FINAL MITIGATION PLAN

Catbird Site
Davie County, North Carolina

DMS Project #: 100022
Contract #: 7186
USACE Action ID: SAW-2017-01506
DWR Project #20171039
RFP: 16-006993

Re: NCIRT Review and USACE Approval of the Catbird Mitigation Plan; SAW-2017-01506; NCDMS Project # 100022

Figure 1 - Vicinity Map
Catbird Mitigation Site
 Davie County, North Carolina

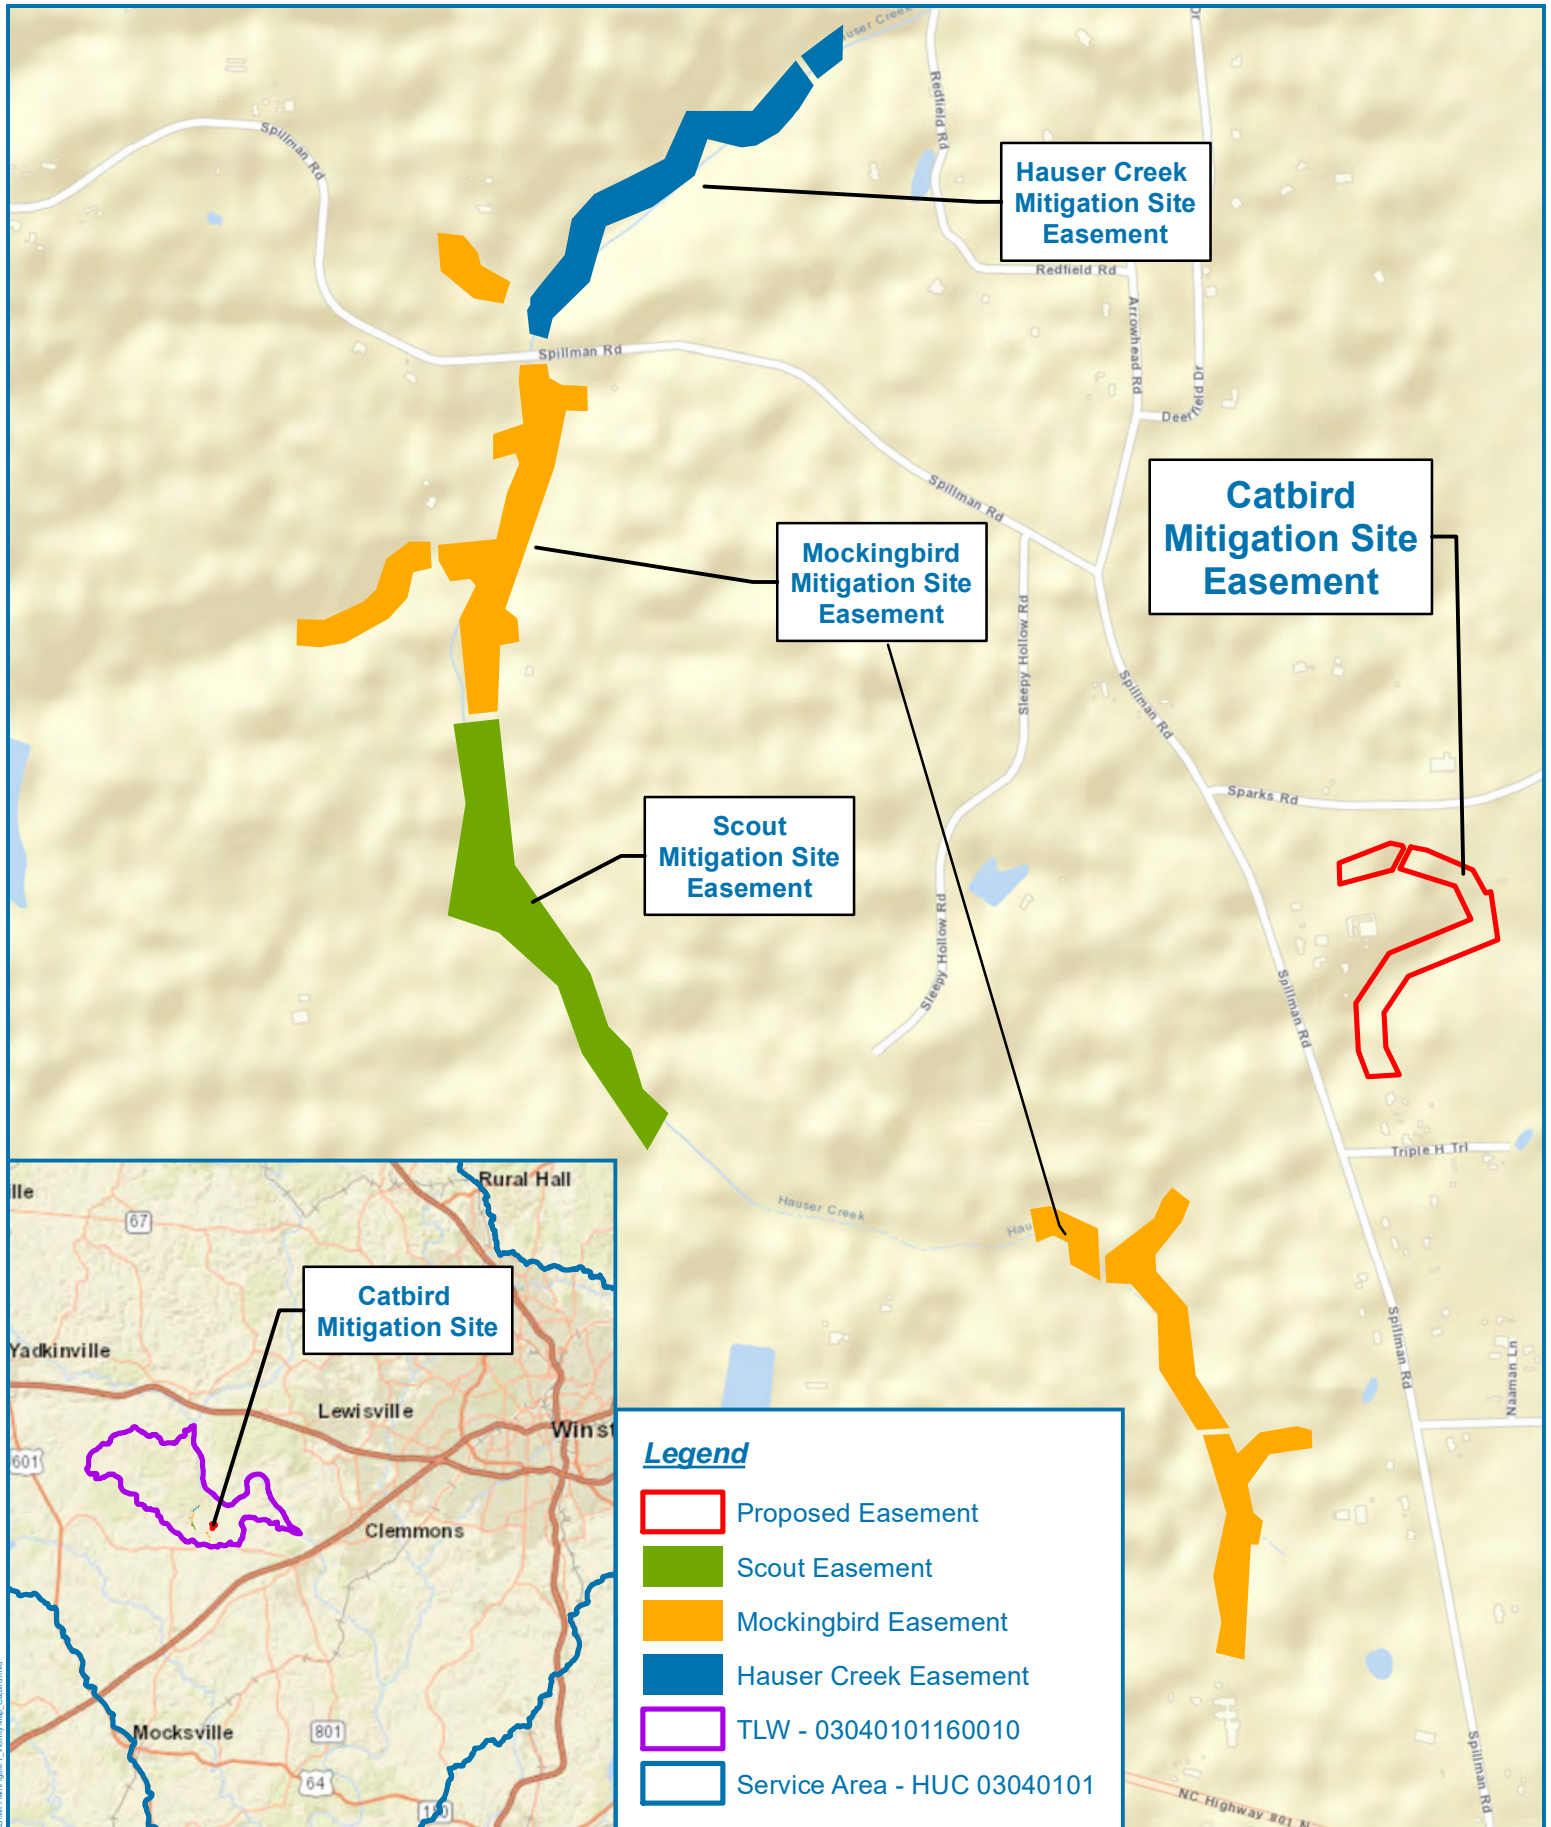
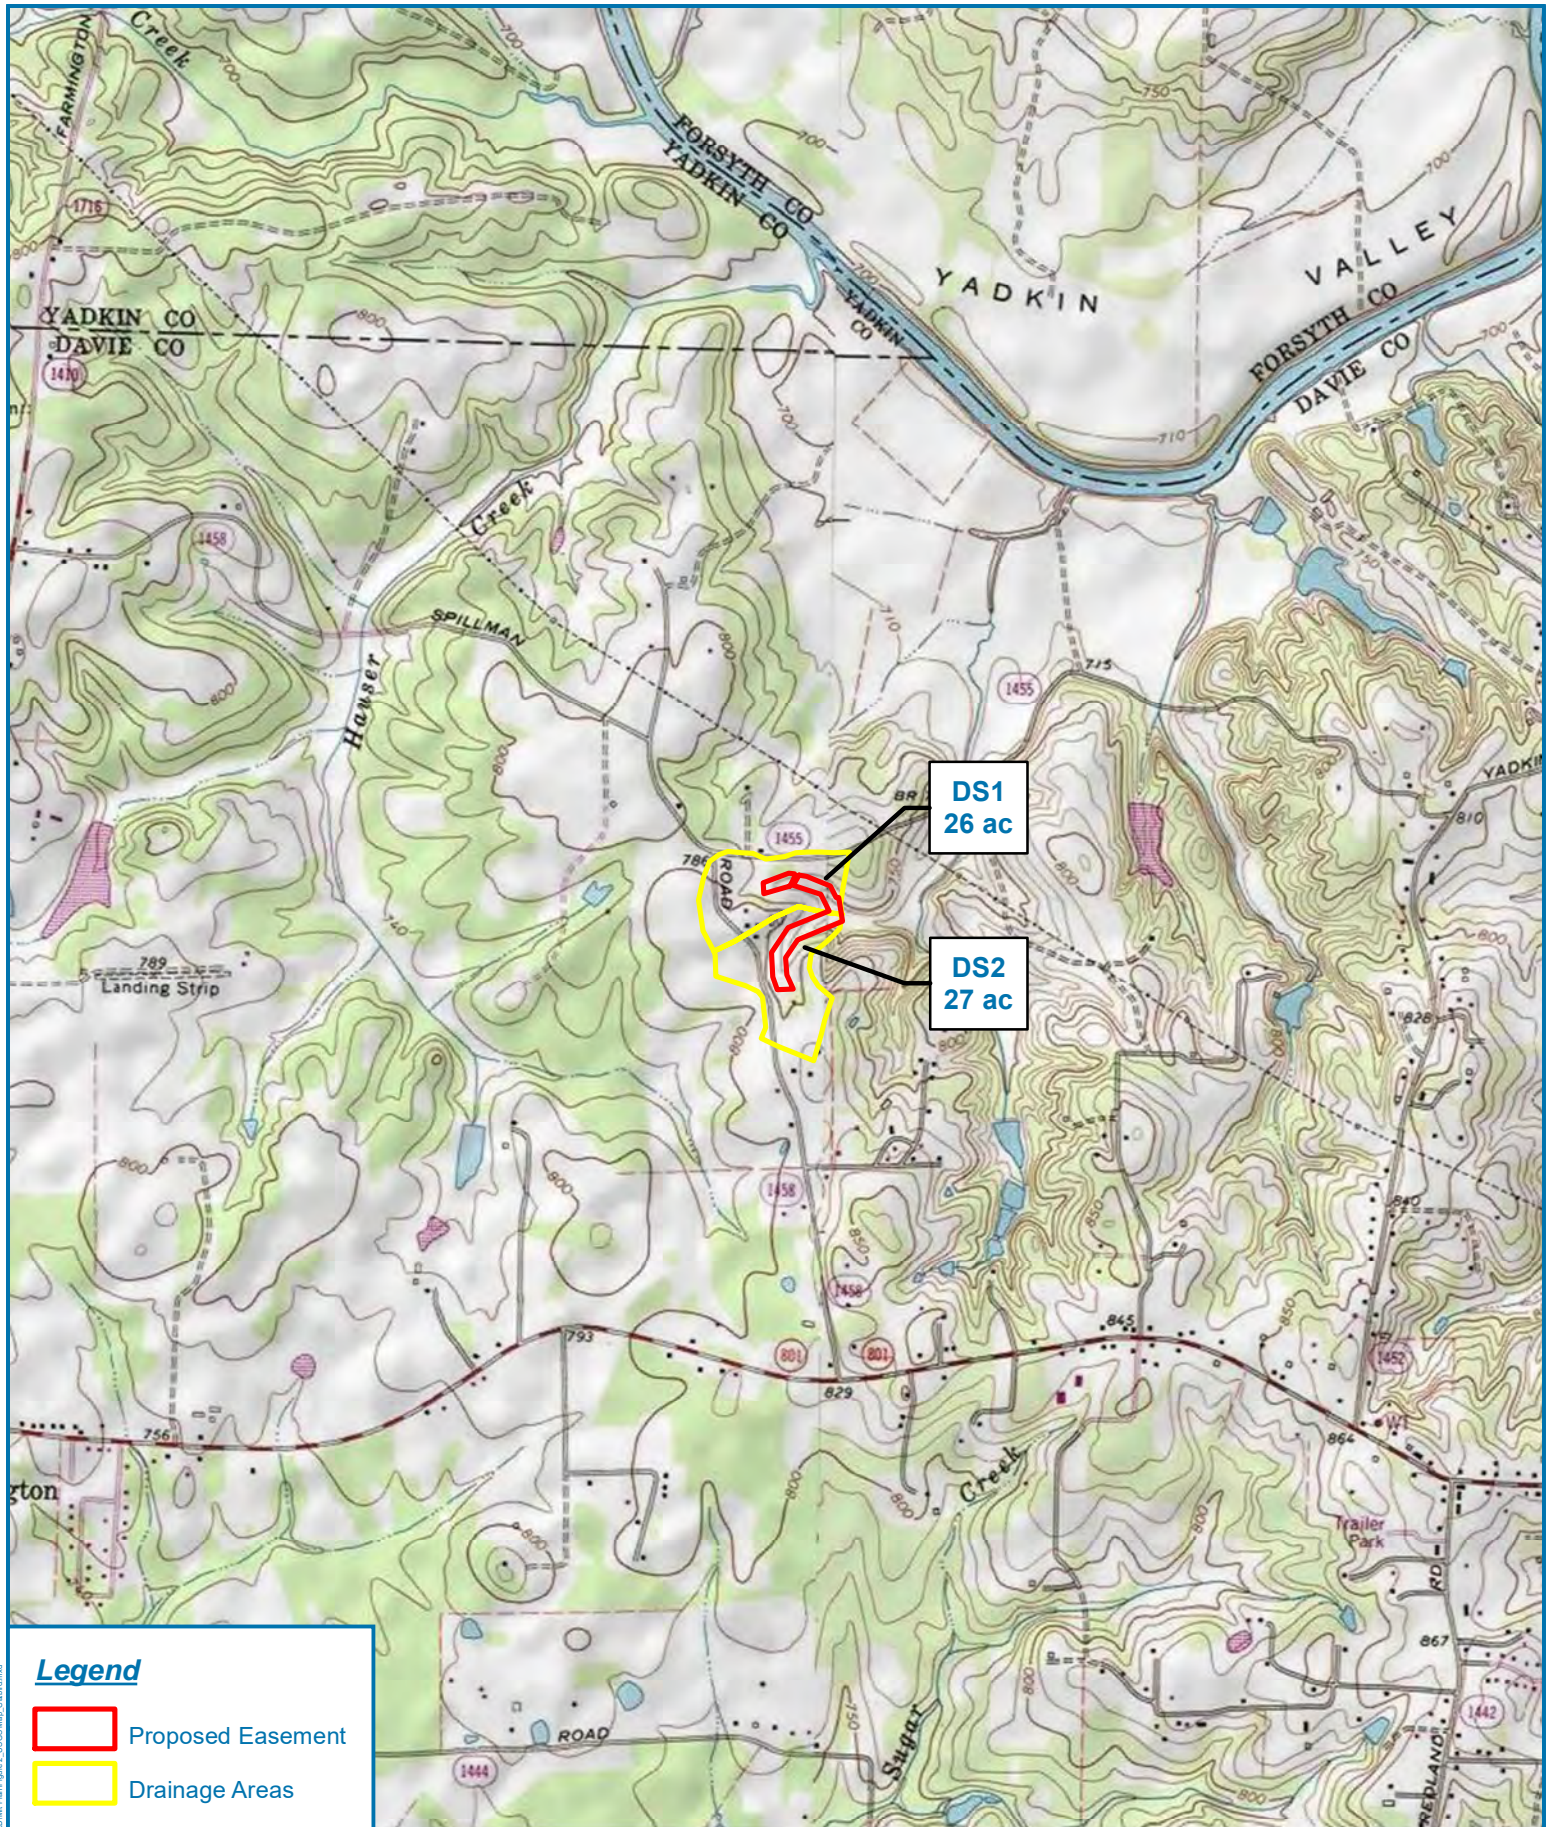
- a) Figure 1, Vicinity Map: Add text boxes with leaders to call out the several sites shown on the figure.
This revision was made to the Figure 1.
- Figure 10:

Figure 10 - Conceptual Map
Catbird Mitigation Site
 Davie County, North Carolina

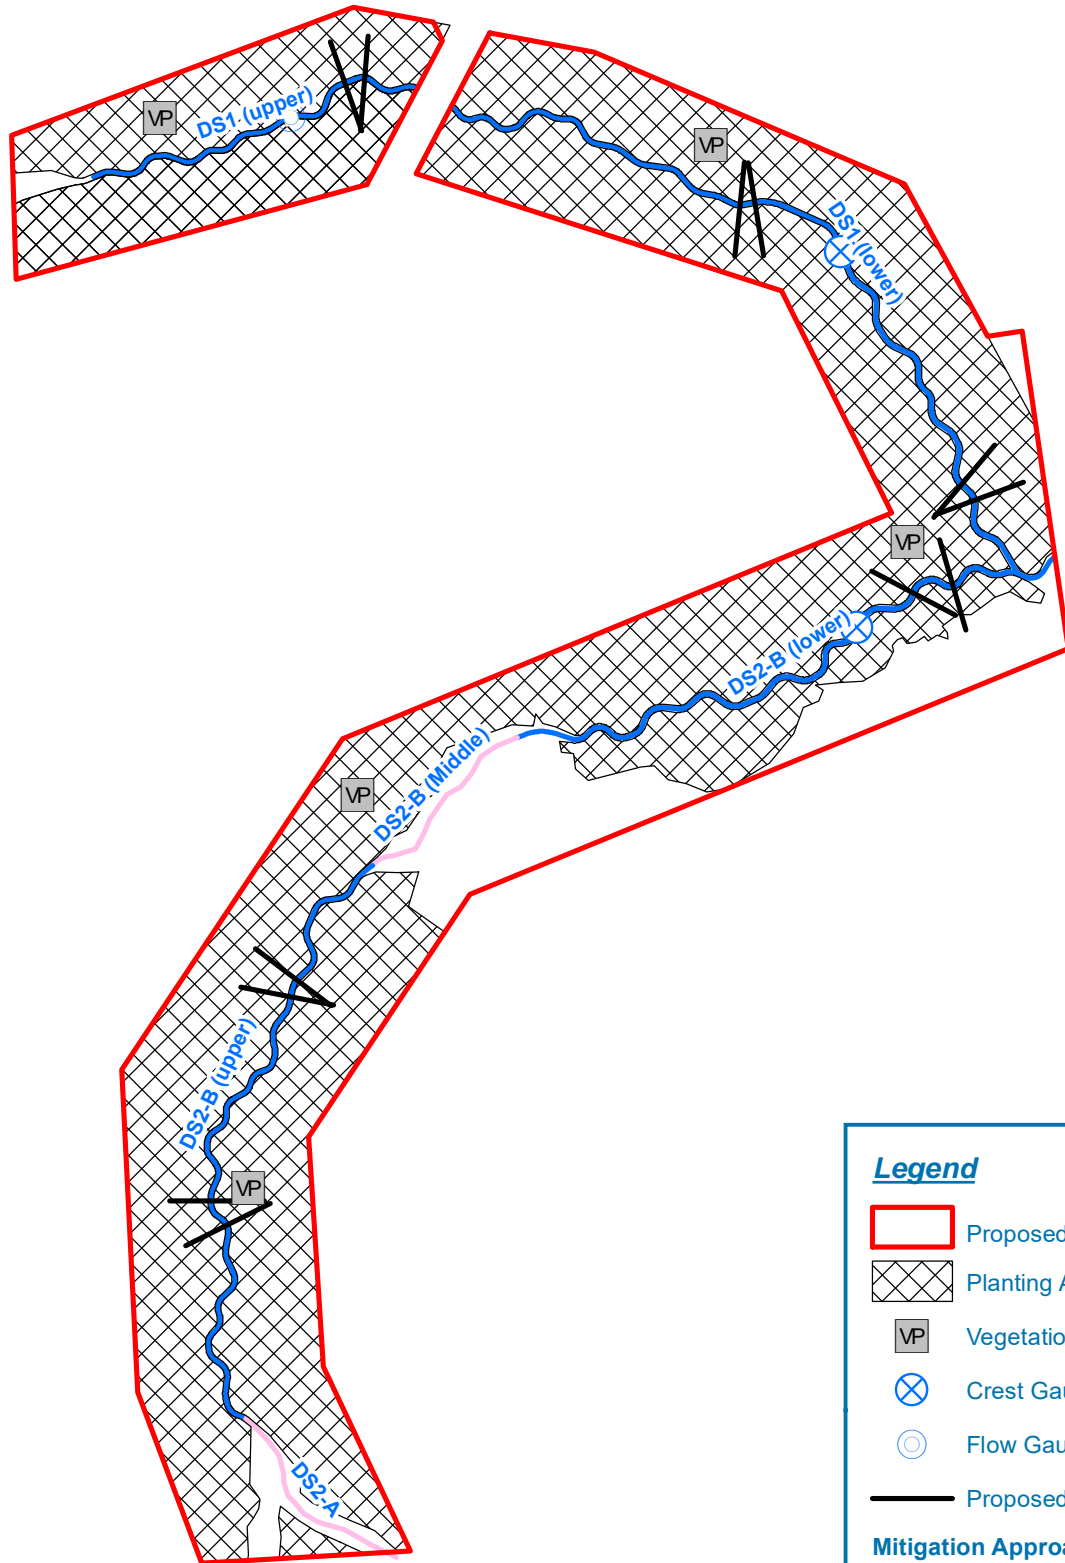
- b) Mitigation work plan indicates that an agricultural BMP will be placed at the upper end of DS-1; please show this on the conceptual map.
This revision was made to the Figure 10.

- c) Please indicate planned culvert crossing on the map.
This revision was made to the Figure 10.
 - d) Please show reach breaks more clearly to match up with the asset table; for example it is not shown where DS-2B starts, where DS-1 (above crossing?) and DS-1 (below crossing?) start and stop. Typically, there is a unique Reach ID assigned for each unique reach / approach combination. Suggest labelling reaches such as DS-1 (upper), DS-1 (lower), DS-2A, DS-2B (upper), DS-2B (middle), DS-2B (lower), or similar. This will make for easier database and asset tracking, credit release discussions, etc.
The labels in Figure 10 and the table in Figure 10 have been revised to more clearly designate where the reaches start and stop. The Table 15 has also been revised to correlate with this revision.

Figure 11 - Monitoring Plan Map
Catbird Mitigation Site
 Davie County, North Carolina

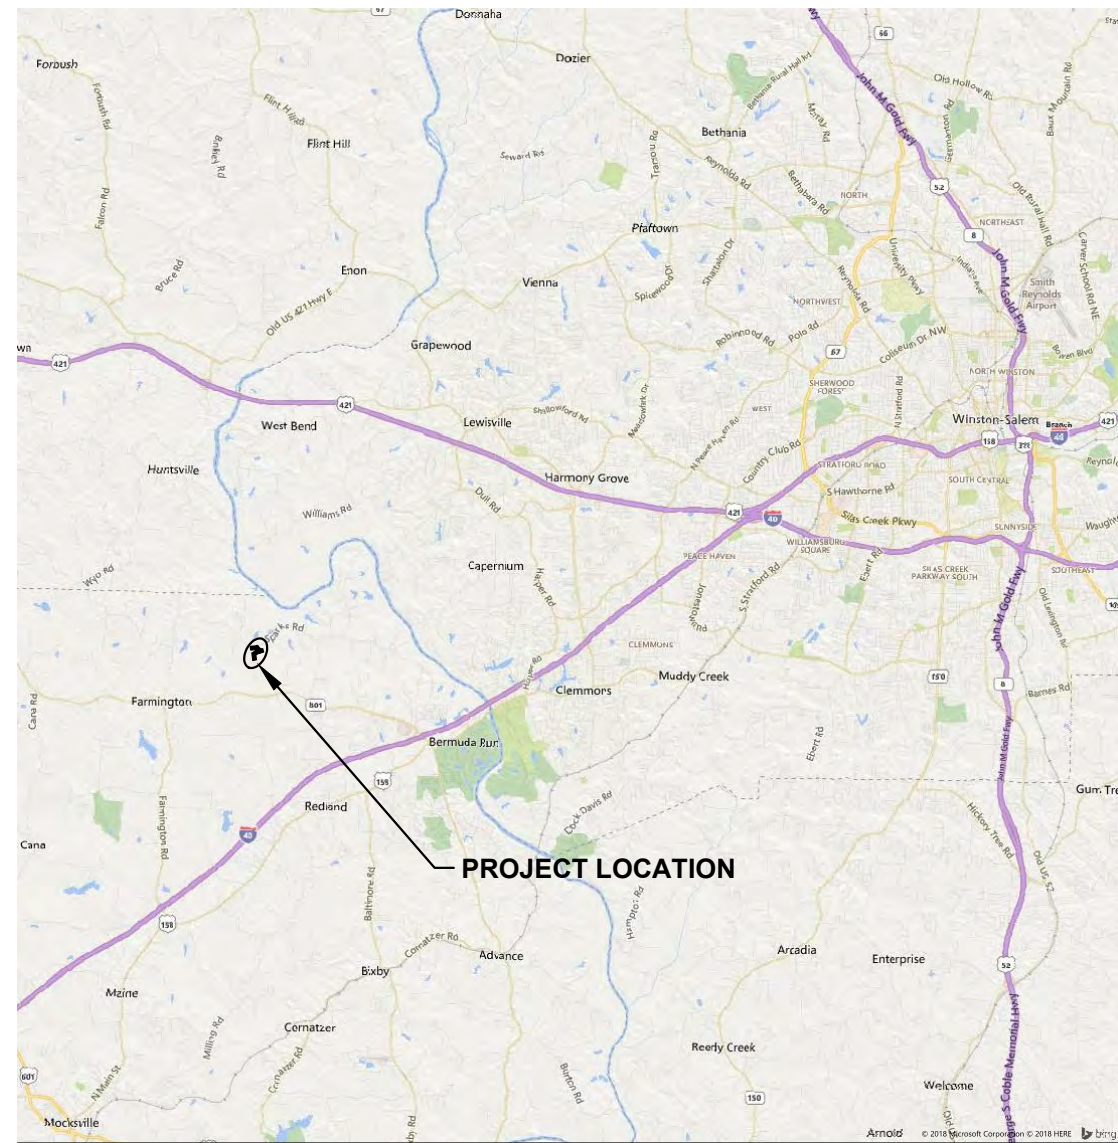
2. Please include a monitoring map which includes the location of veg plots, flow gauges, photo locations, and crest gauges, similar to sheet M1. [This has been included as Figure 11. Also, we realized there were far too many cross sections on the original monitoring sheet and both Sheet M1 and Figure 11 reflect these changes.](#)
